Access Compliance Report

Public Rights-of-Way

(Pedestrian Signals)

Intersection ID: N/A	Main Street:	Cross Street: N/A	Location: N/A
ADA ID: 4EADC58711BA	Signal Type: One Push Button-Non APS	Overall Compliance: No	Severity Score: BTN 1: N/A BTN 2: N/A No BTN: N/A
Codes/Mitigation Info/Possible Solution		Field Measurements/Component Compliance

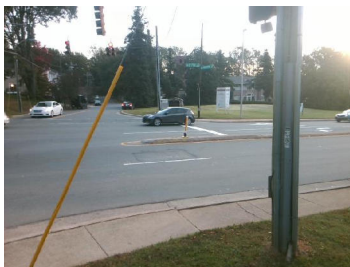
PROW/ADA: TMUTCD 4e.08, R404.1, R404.7.3

Yes	B 1 Clear Xing Direction?	ClearlyMarked	N/A	B 2 Clear Xing Direction?	N/A
	B 1 Crossing Direction	To NW		B 2 Crossing Direction	N/A
Yes	B 1 DistanceTo XWalk (in)	0.0	N/A	B 2 DistanceTo XWalk (in)	N/A
No	B 1 DistanceTo Curb (in)	88.0	N/A	B 2 DistanceTo Curb (in)	N/A
Yes	B 1 Diameter (in)	2.0	N/A	B 2 Diameter (in)	N/A

Possible Solutions: Replace Signal Push Button With APS Button on New Post. Remove & Relocate Sign.
